**49 CFR Parts 216 and 238
Passenger Equipment Safety Standards;
Final Rule**

ACTION: Final rule; response to petitions for reconsideration.

SUMMARY: This document responds to certain of the petitions for reconsideration of FRA's May 12, 1999 final rule establishing comprehensive Federal safety standards for railroad passenger equipment. This document clarifies and amends the final rule.

Figure 2

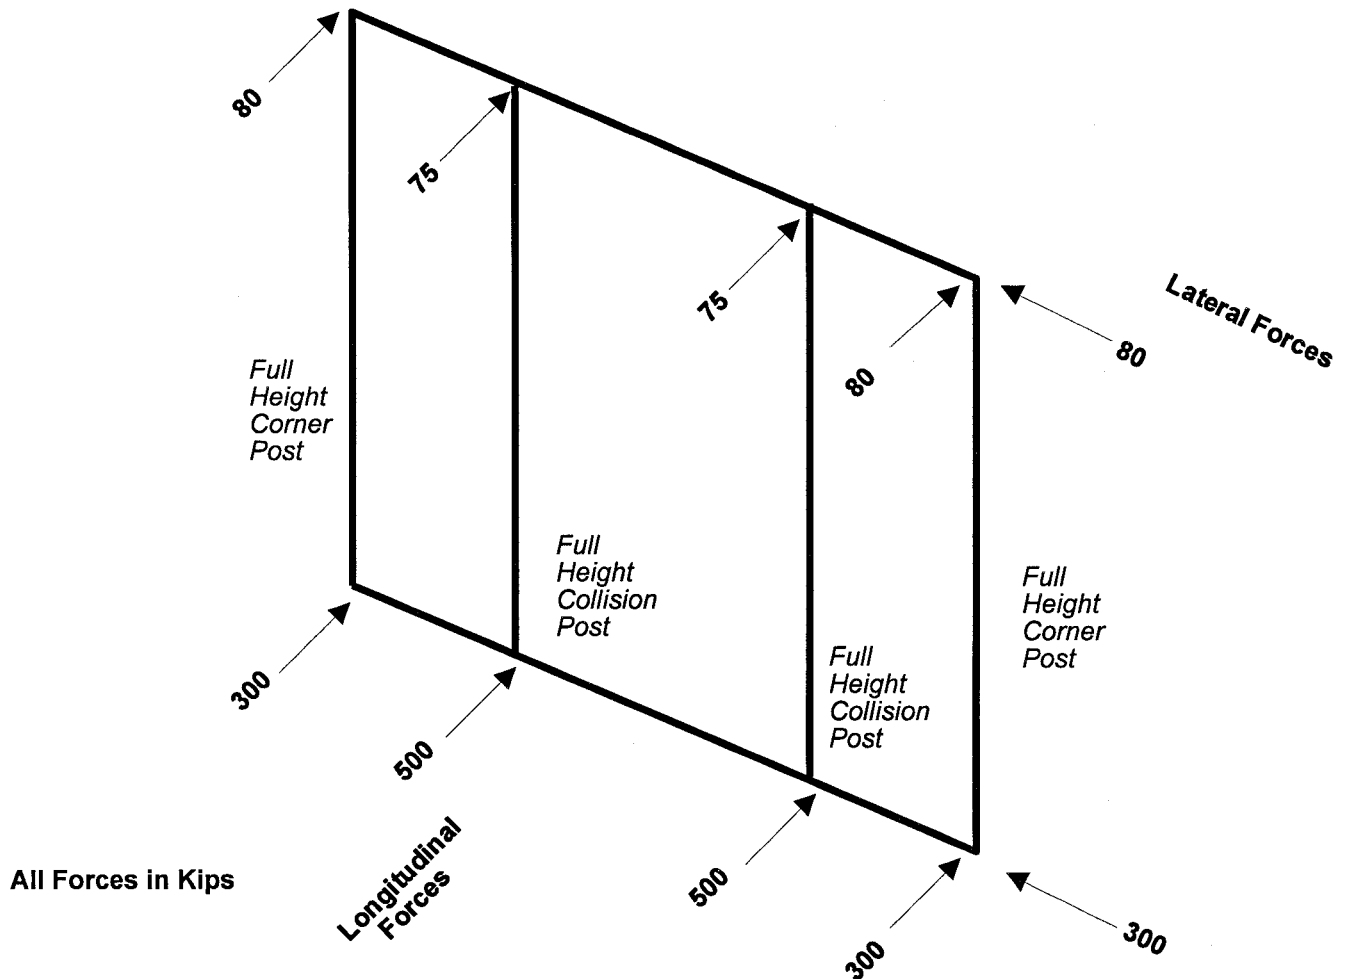
FRA has adopted Bombardier's request and modified paragraph (b)(1) accordingly. (FRA has also made a

corresponding change to figure 2 to subpart E.) FRA recognizes that the strength of the power car cab's rear collision posts should not necessarily be dependent on the strength of the cab's front end structure, as the front and rear end structures are intended to protect against somewhat different hazards. The front end structure must protect against the greater hazard of a head-on collision with another train or object.

30. Figure 2 to subpart E is revised to read as follows:
